February 5, 2019  
L-18-242

Davis-Besse Nuclear Power Station, Unit No. 1  
Docket No. 50-346, License No. NPF-3  
License Amendment Request – Proposed License and Associated Technical Specification  
Changes for Permanently Defueled Condition

**Evaluation of Proposed Changes**

Figure 3.7.16-1 (page 1 of 1)  
Burnup versus Enrichment Curve for  
Spent Fuel Pool Storage Racks

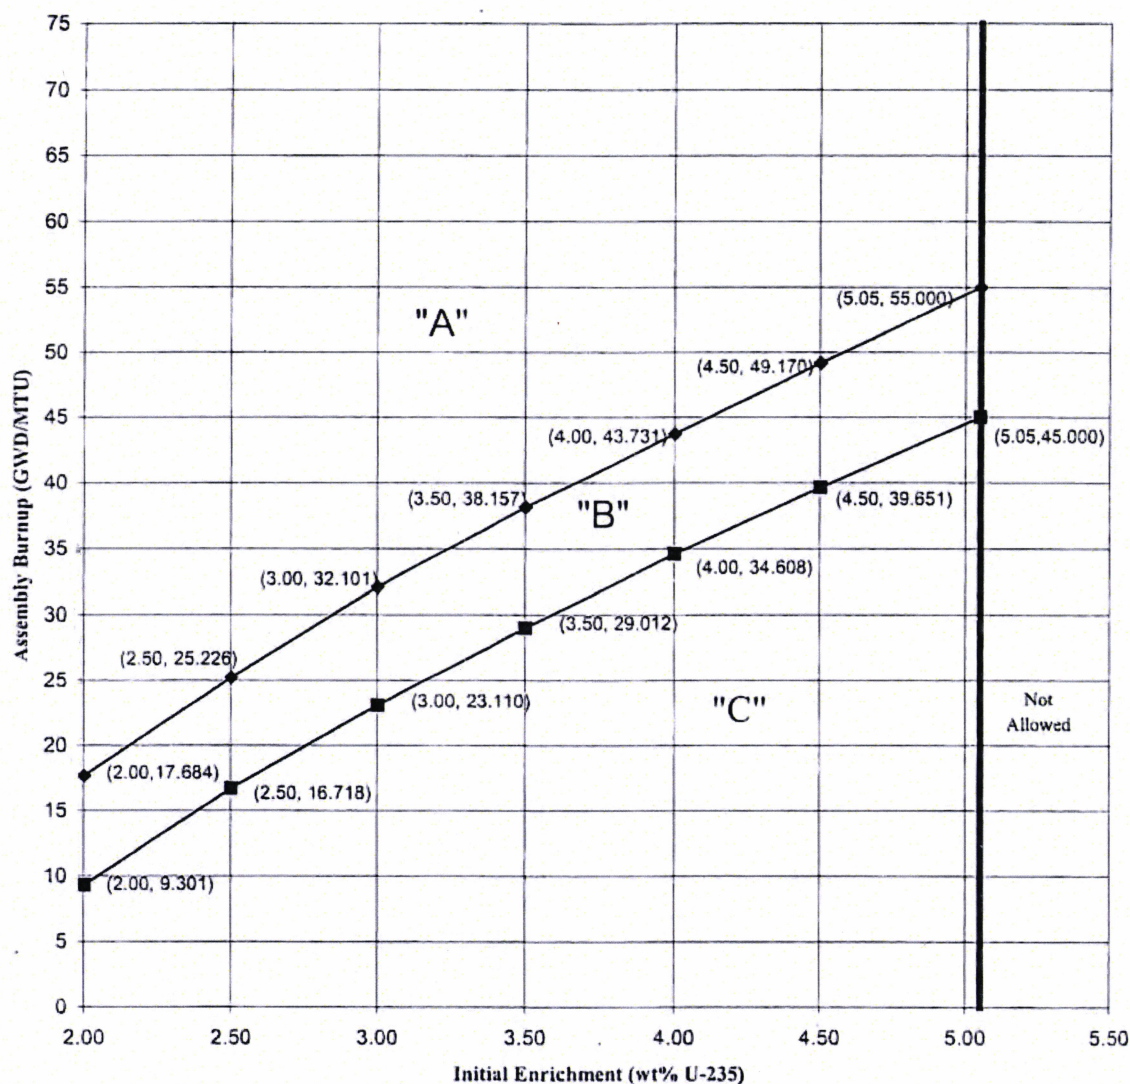
MZTR is a loading pattern where ~~fresh or~~ low burnup assemblies (identified as Region 1 assemblies) are separated from each other and from intermediate burnup fuel assemblies (identified as Region 3 assemblies) by barrier fuel assemblies with high burnup (identified as Region 2 assemblies). CB is a loading pattern of empty cells, or cells with non-fuel bearing components, and cells with ~~fresh or~~ low burnup assemblies (Region 1). HL is a loading pattern of intermediate burnup fuel assemblies (Region 3). Region 2 assemblies correspond to Category A in Figure 3.7.16-1, Region 3 assemblies correspond to Category B in Figure 3.7.16-1, and Region 1 assemblies correspond to Category C in Figure 3.7.16-1. ← New fuel is no longer stored onsite.
